RE: Florida Power Corporation
Tiger Bay Facility Power Plant Site Certification Application

Re: Tiger Bay Cogeneration Facility
Draft Title V Permit No.: 1050023-002-AV

Re: 7FA Gas Turbine Soft Start Sequence

7F/FA MSCC W/IBH

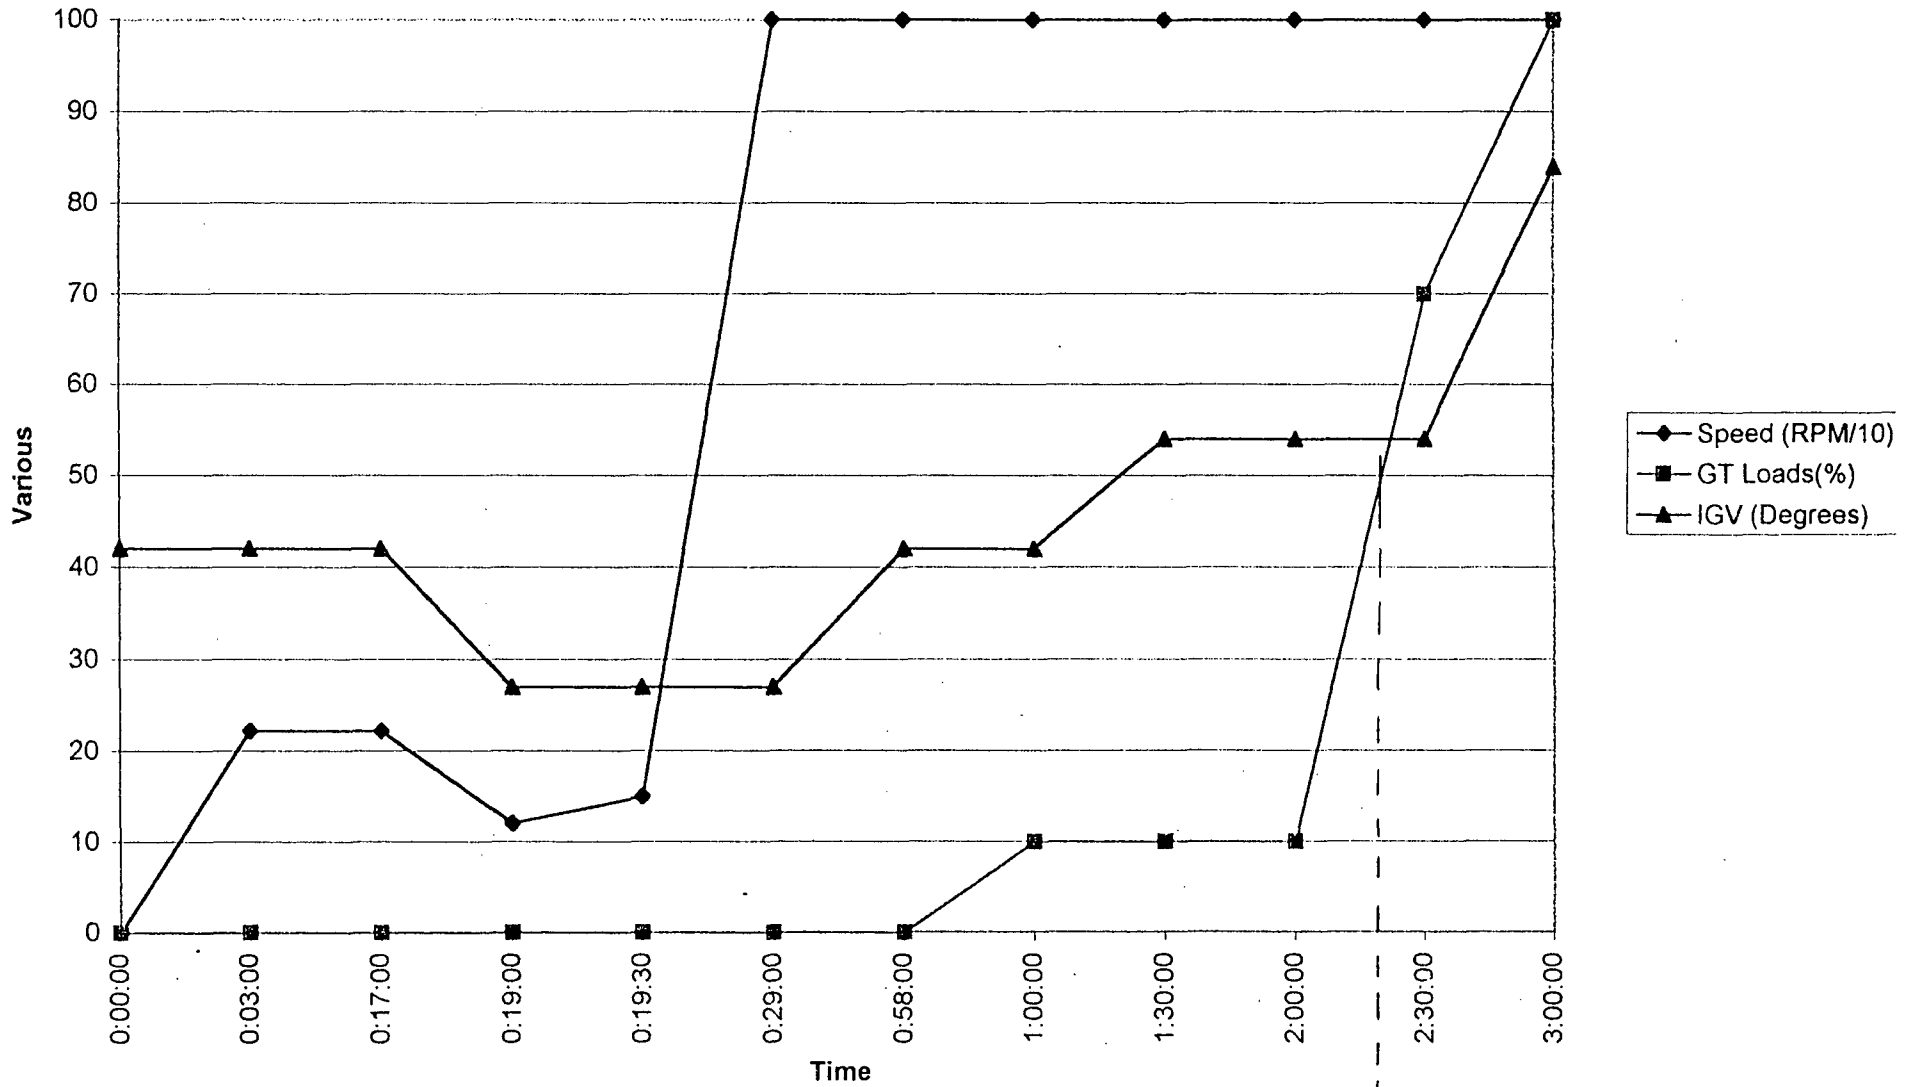
13. Page 11. Condition A.35. In accordance with the attached start-up curve, FPC requests that this unit be specifically authorized to have excess emissions for 3 hours (rather than 2 hours) in any 24-hour period, unless specifically authorized by the Department for longer duration. Also, the pertinent excess emission provisions of 40 CFR Part 60 should be included in this section of the permit, i.e., §§ 60.8(c), 60.11(c), and 60.43c(d).

Of note is the long period at which the gas turbine operates below the steady state pre-mix mode (just over 2 hours from initial start up command). At loads below steady state pre-mix the combustion system is not capable of achieving 25 ppmvd NOx levels. Shortening of the cycle to get the turbine into steady state pre-mix sooner would offset the benefit of allowing the slower warm-up of the turbine rotor and may result in pre-mature failure of turbine components.
